工程指示 / 要求簡箋(E.I.)

工程指示編號：EI / 6704 / 23

工程名稱：將軍澳日出康城 11

工程項目：顧問上廠報告 (6/7-31/8) 精華版加完整版

Photo 5

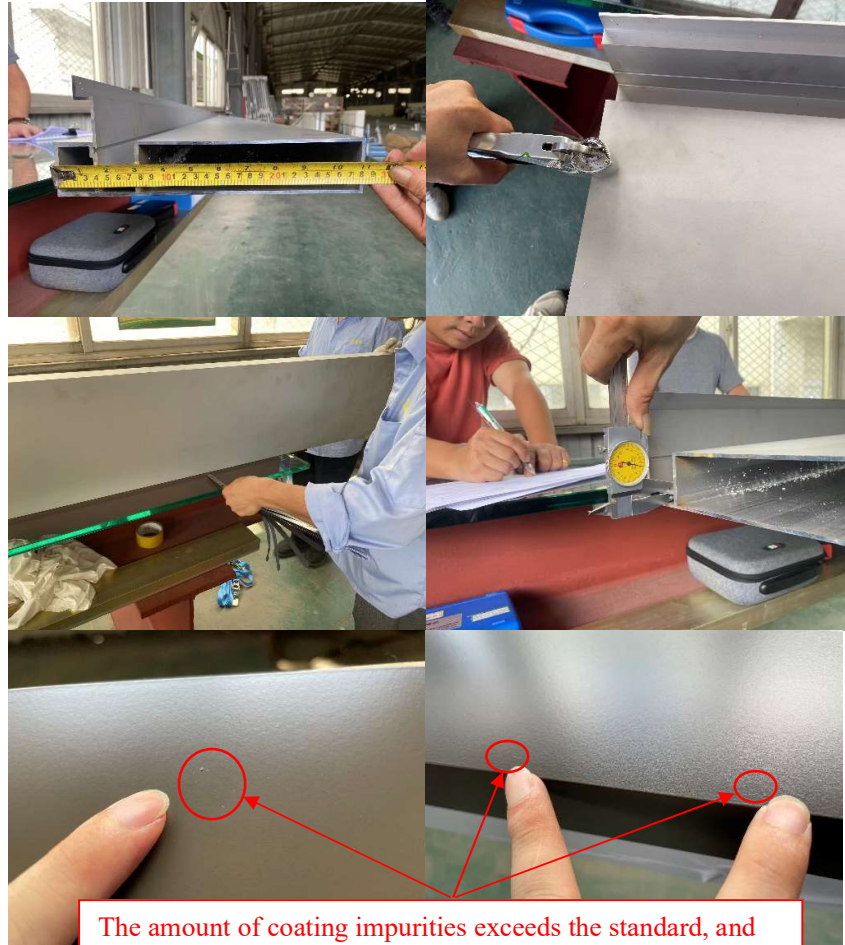
Action:
- The amount of coating
impurities exceeds the
standard, and the supplier
should improve the quality
standard

The amount of coating impurities exceeds the standard, and the supplier should improve the quality standard

清: 影返相關鋁
料，影靚仔面的。

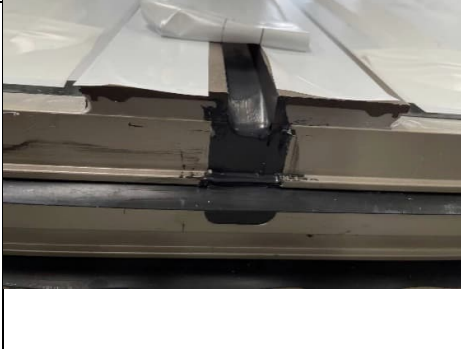
<p>Photo 7</p>		
<p><u>Location:</u> 湖南廠</p>		
<p><u>Observation</u> <u>Description:</u> Apply structural sealant for T1 36/F to 40/F MO21</p>		
<p><u>Action:</u> MIDI is reminded to carry out the remedial works prior products delivery and to improve workmanship for future works</p>	<p style="color: red; border: 1px solid red; padding: 5px;">Structural sealant overflow needs to be redone on T1 38/F. MIDI QC is reminded check the sealant overflow.</p>

清: T1 38F 影張無膠的相。
